## HISTORIC AND DESIGN REVIEW COMMISSION

**HDRC CASE NO:** 2017-494

**ADDRESS:** 107 W CRAIG PLACE

OWNER: Cappy Lawton/C&S Lawton Properties LTD
TYPE OF WORK: Widening of existing driveway and apron

DECEMBER - 20 84 40. S.B. D.R. N.A. SURVEY PLAT OF

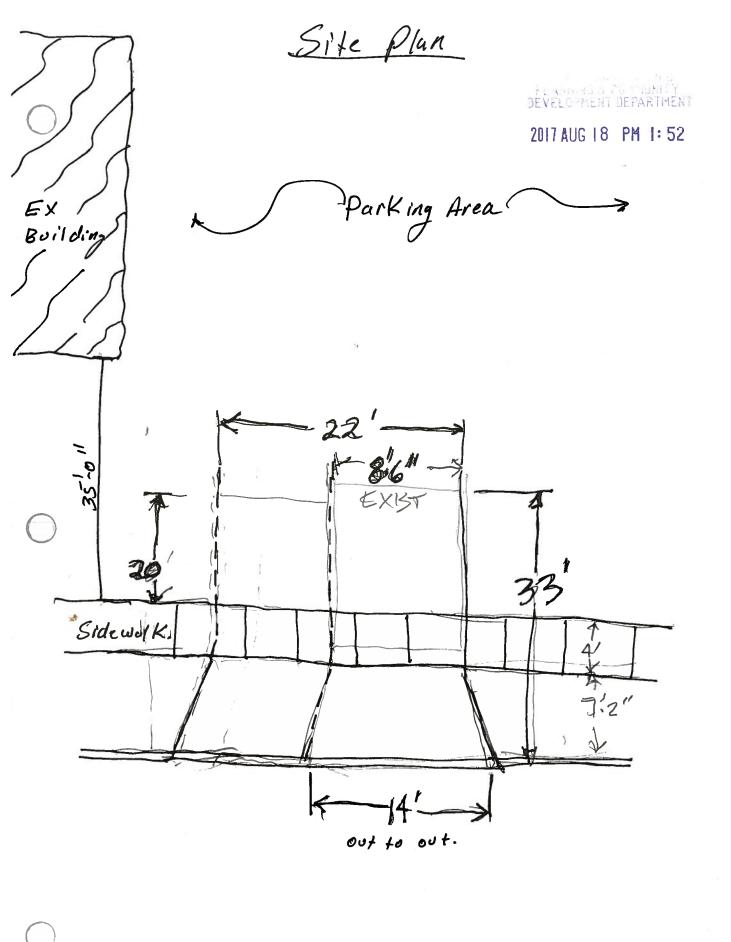
Staff recommends approval based on findings a and b with the stipulation that the driveway and apron are consistent in width with the driveway across the street. The applicant should provide staff with dimensions that verify the existing driveway conditions and submit an updated site plan that responds to these dimensions prior to receiving a Certificate of Appropriateness.
